Certificate of Appropriateness Application (Historic Conservation District)
BAR 18-11-01
128 Franklin Street
Tax Parcel 560114400
Sam Monfort, Owner/Applicant
New Construction

CITY OF CHARLOTTESVILLE
BOARD OF ARCHITECTURAL REVIEW
STAFF REPORT
November 20, 2018

MONFORT RESIDENCE

128 FRANKLIN ST.
 CHARLOTTESVILLE, VIRGINIA

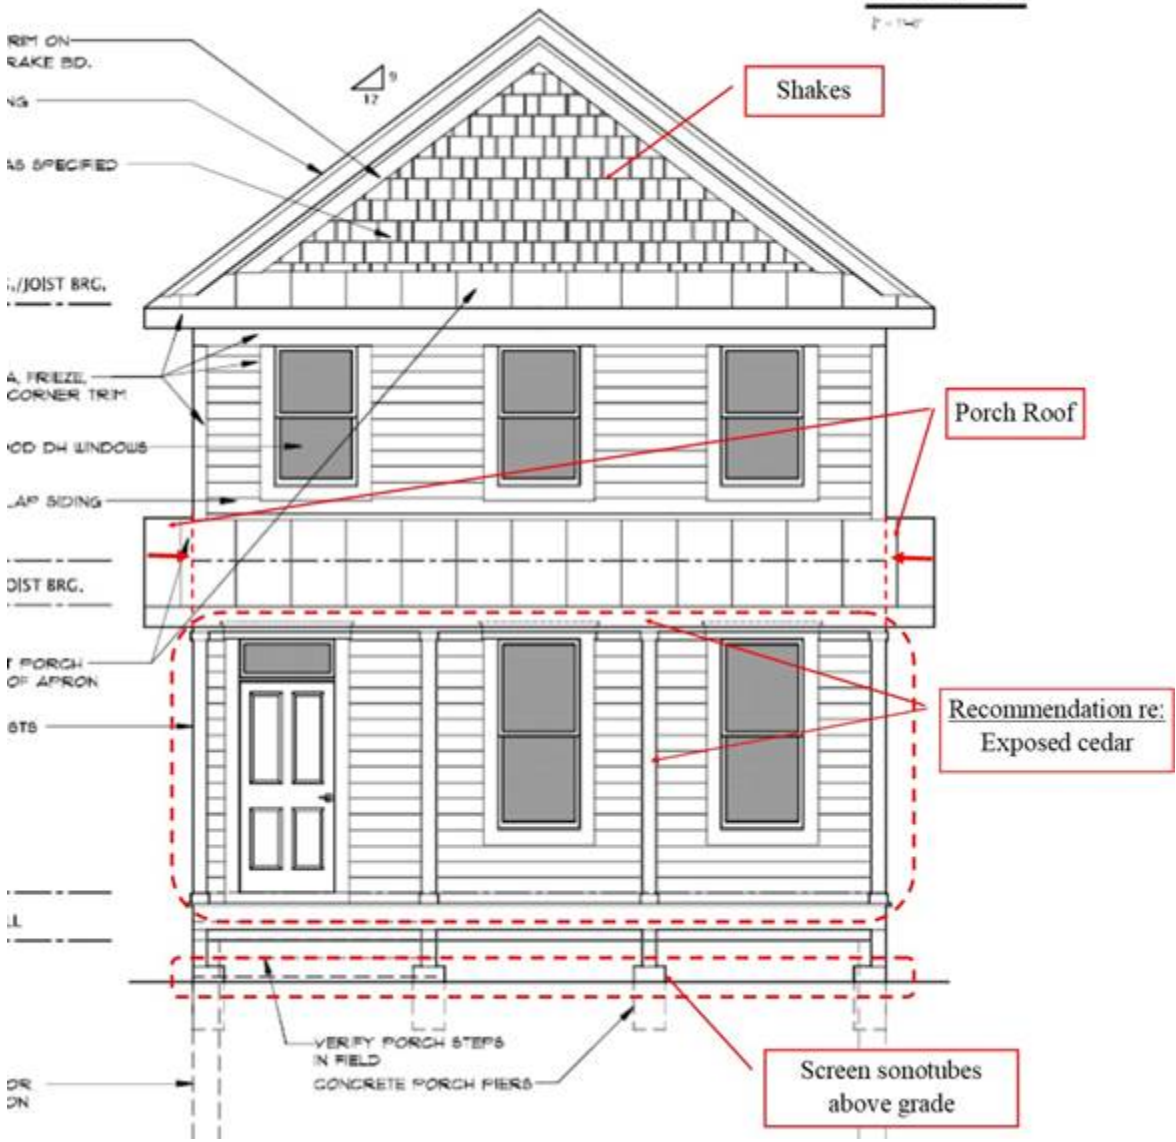
See the image below. We can discuss all of this next week

- Porch roof: BAR didn't know if you intended the overhang or not; they preferred that it not, but you can make the case in Dec, if you want.
- Shakes: while the Hist Cons District rules are far less stringent, the BAR still felt the Hardie product would not result in the desired look.
- Sonotubes: tell builder to keep them low, then maybe screen with plants.
- Cedar on porch: Unclear whether or not you intended to stain or paint them. BAR prefers they not be bare wood, but you can make the case in Dec, if you want.

A-2

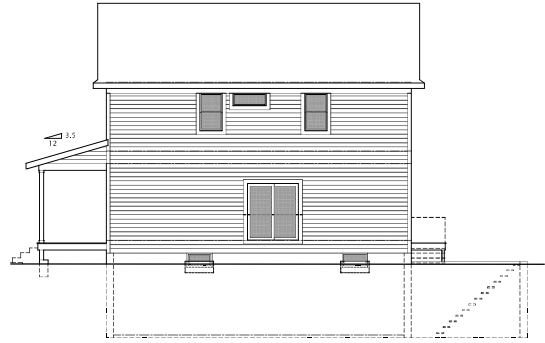
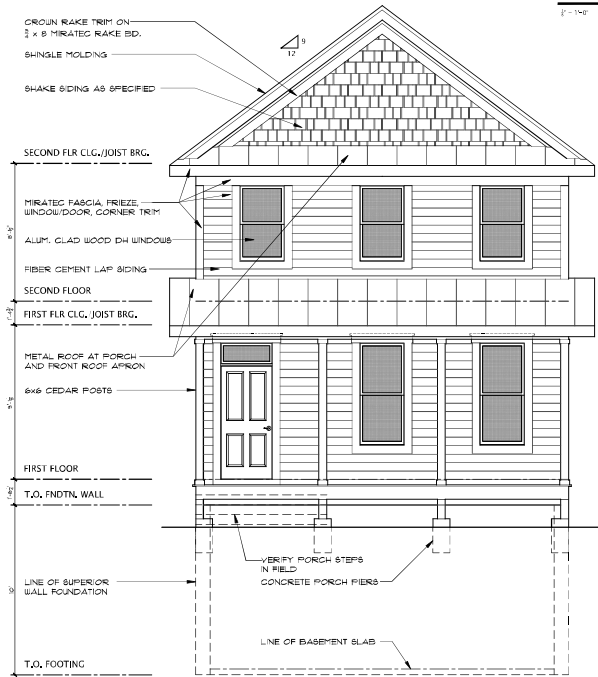
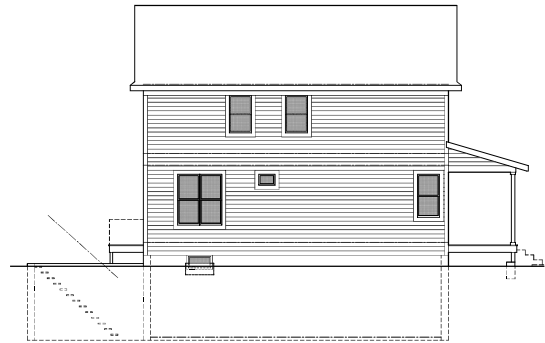
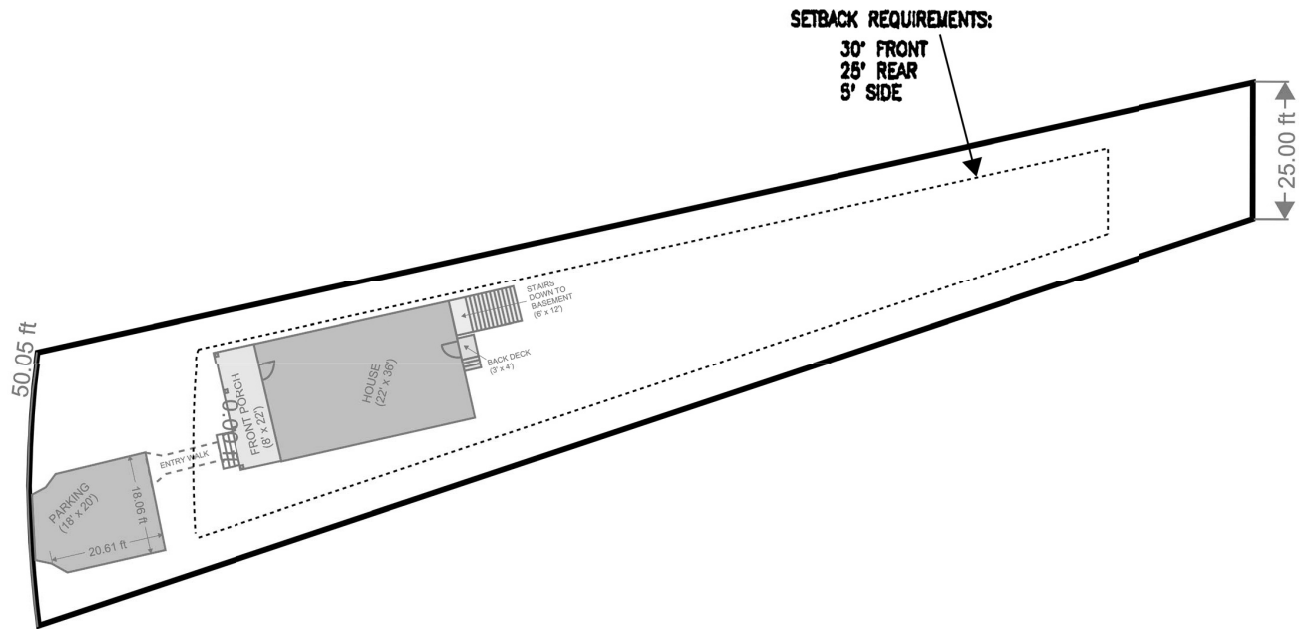
- [sides of] Front porch roof brought within the width of the house
- Cementitious shakes change to cedar shakes [at front pediment]
- Sonotubes [at front porch] be appropriately screened
- Strong recommendation that cedar on front porch be painted
